CITY OF VAUGHAN

EXTRACT FROM COUNCIL MEETING MINUTES OF SEPTEMBER 27, 2021

TITLE: APPEAL TO SIGN VARIANCE APPLICATION SV 20-004

251 Doney Crescent, Concord, ON

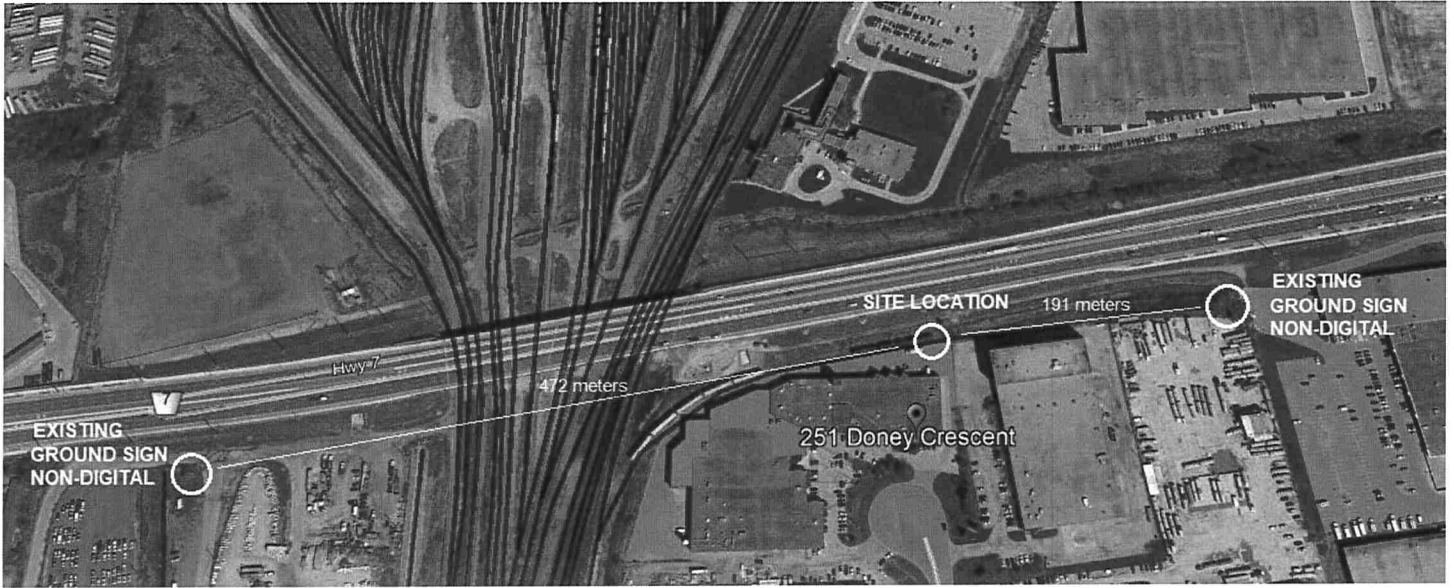
The requirement contained in Section 15.1 part d), that signage not exceed 8.0 metres in height measured from the finished grade level at the base of the supporting structure, *be varied* to allow a billboard to be erected an additional 5.2 meters over the imposed limit.

The variance is required due to its location well below the overpass on the southeast side of the bridge. The actual base of the sign will be located nine meters below the grade level of the overpass. The additional height is necessary so that clarity and readability can be fully achieved without drivers exerting undue efforts to view it. The fact that the base of the sign will be located nine meters below the grade level of the overpass, an additional height of only 5.2 meters is required. This is similar to the digital sign erected on the northwest side of the overpass which exceeds the height limit of 8.0 meters.

The requirement contained in Section 15.1 part c), that signage not exceed a maximum Sign Area of 20.0 square metres for any single Sign Face with a total Sign Area of 40 square metres for all Sign Faces combined, *be varied* to allow the sign area to be 62.43 square meters for each sign face.

In order to ensure visibility and readability, the surface area of the signage requested is 62.43 square meters with illumination limits according to section 19.1 of the bylaws. The additional 22.43 square meters is needed because, Highway 7 is major road with 8 lanes wide (including transit) compared to a city street with just 2-4 lanes wide. The added sign face area will help to overcome the challenge of the extended distance the sign will be located, approximately 40 meters from the centre line of Highway 7.

The existing digital sign erected on the northwest side of the overpass also exceeds the sign face area by 20.0 square meters.

PROPOSED ARTIST RENDERING.
251 DONEY CRESCENT, CONCORD, ON

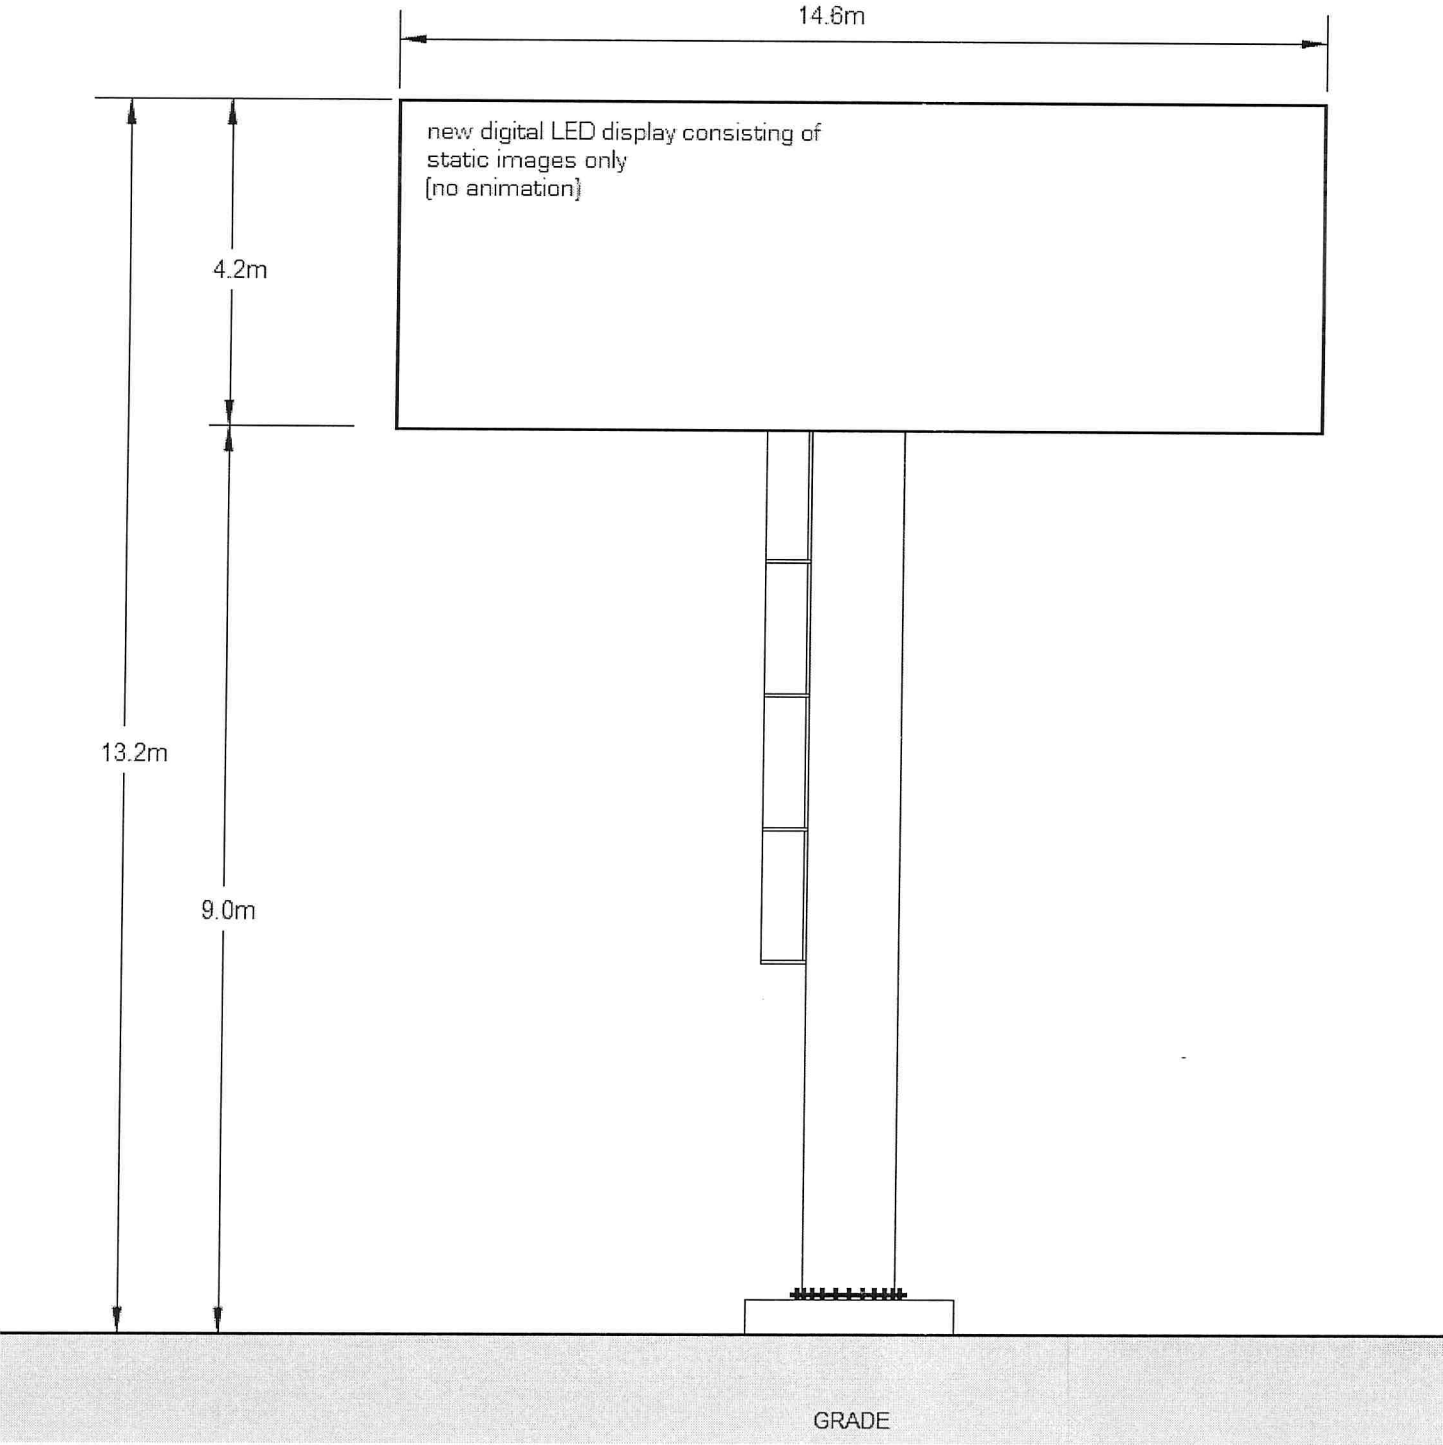
The requirement contained in Section 15.1 part g), that signage be 600 meters from any other billboard, located on the same side of the street, *be varied* to allow a billboard to be erected 191 meters from the nearest billboard and 472 meters from the second nearest billboard.

A sign is located on the west side, a distance away of 472 meters away (1,549 feet) from the proposed sign. Its location on the other side of the tracks and the height of the overpass, is too far away to be affected by the proposed sign.

A current billboard exists 191 meters (626 feet) to the east facing Highway 7. This existing sign is a static board in an industrial zoned lot currently used for parking. The parking lot will soon be developed and the sign will most likely be removed. The proposed signage will have no effect on this existing sign as a large industrial building is situated in between the two signs.

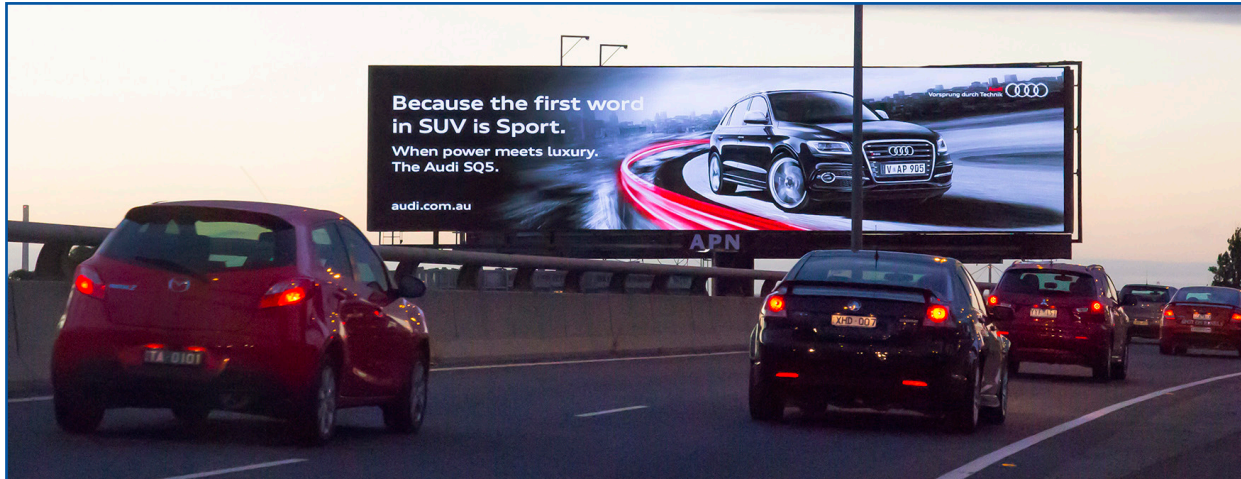
I revised my application to reduce the signage size by over 40% to a maximum size of 3.3m by 11m. This would be in keeping with other signage (boards, bridge ads) installed across the City, which vary greater than 20 sq.m. (i.e. signage at Islington and Steeles is over 63 sq.m).

The variance for height was addressed and accepted at the September 24, 2020 meeting.

The variance for distance to other signage was addressed and accepted at the September 24, 2020 meeting.
